Model: S-P1	Date: 15-Jan-07	No.: RG176001a
-------------	-----------------	----------------

Subject: Firmware Release Note: Engine for S-P1b (31ppm)		Prepared by: Y.Murata	
From: 1st Tech. Support Sec. Service Support Dept.			
Classification:	<input type="checkbox"/> Troubleshooting <input type="checkbox"/> Mechanical <input type="checkbox"/> Paper path <input checked="" type="checkbox"/> Other ()	<input type="checkbox"/> Part information <input type="checkbox"/> Electrical <input type="checkbox"/> Transmit/receive	<input type="checkbox"/> Action required <input type="checkbox"/> Service manual revision <input type="checkbox"/> Retrofit information

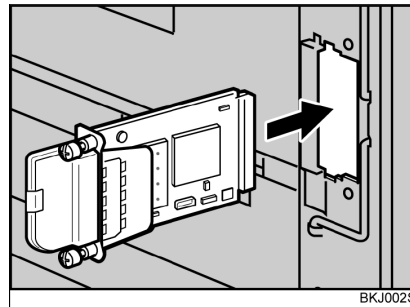
Previous types:
PCB, LAN card, and cover are
separate

New Type (IEEE802.11b
Interface Unit Type N):
Pre-assembled

Parts Catalog, pg. 2

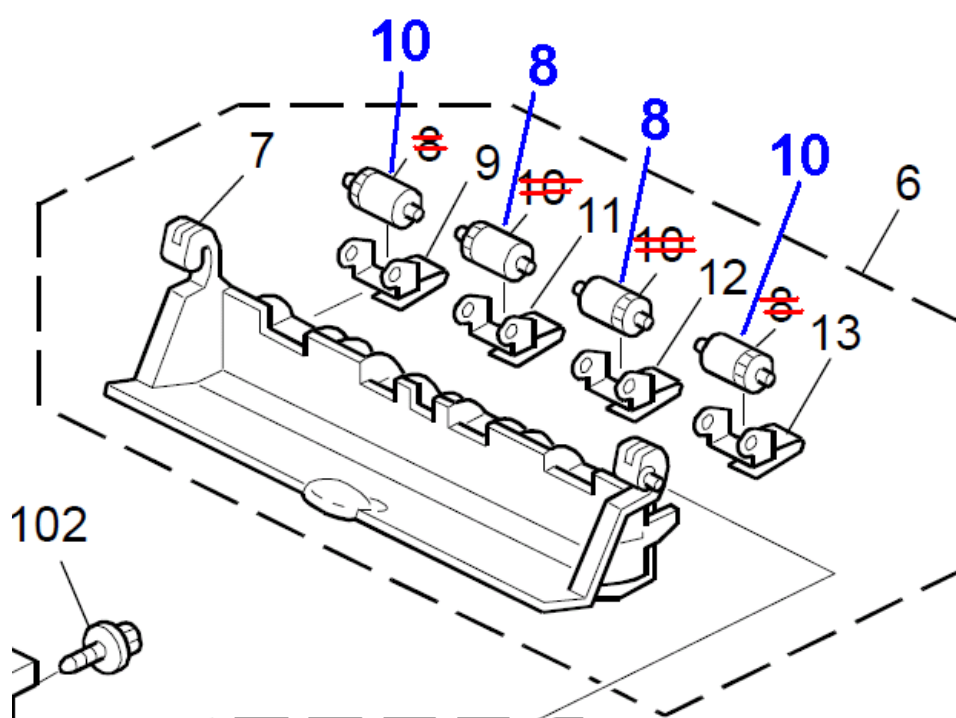
Change/Reason: Indices #8 and #10 were corrected (they were reversed).

6	G096 1509	Paper Exit Sub-unit Ass'y	1
7	G096 1512	Exit Cover	1
8	G052 4875	Inner Exit Cover Roller	2
9	G052 4871	Left Holder - Exit Driven Roller	1
10	G052 4873	Outer Exit Cover Roller	2
11	G052 4876	Left Spring Plate	1
